**Western Star
Service Bulletin**

88-13

Reducing Excessive Hood Opening Effort, 4900 Models

Fig. 1, Hood Tilt-Assist Spring Installation

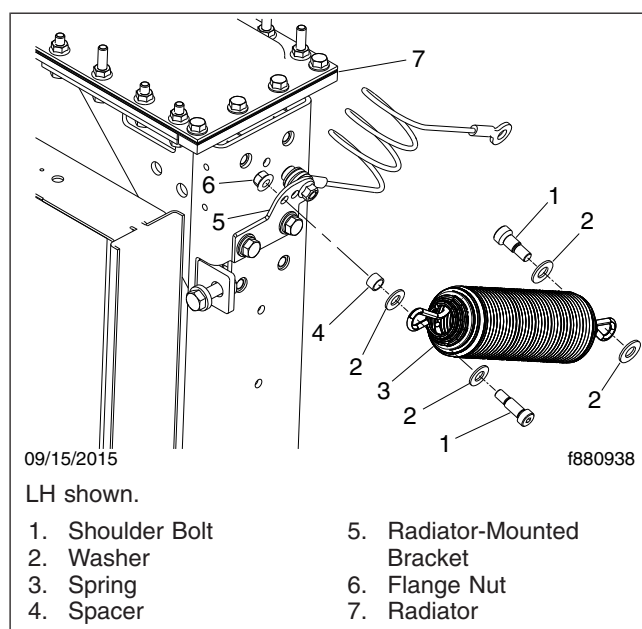
On some Western Star 4900SF 123BBC vehicles, the hood may be too heavy for one person to open. This is caused by variation in hood material thickness, which can increase the hood weight. A new hood tilt-assist spring is available to reduce the hood opening effort. If the hood is too heavy to open, replace the hood tilt-assist springs using the procedure in this bulletin.

1. Park the vehicle on a level surface, shut down the engine, and chock the tires. Open the hood.
2. Tip the hood back about-half-way, until it is balanced over the pivot. Prop the hood in this position or have another person support it there.
3. Detach the hood tilt-assist springs from the radiator-mounted brackets and the hood. See [Fig. 1](#).

4. Attach the new springs (BTS 300156) to the radiator-mounted bracket and the hood. Tighten the fasteners 16 lbf-ft (21 N-m).
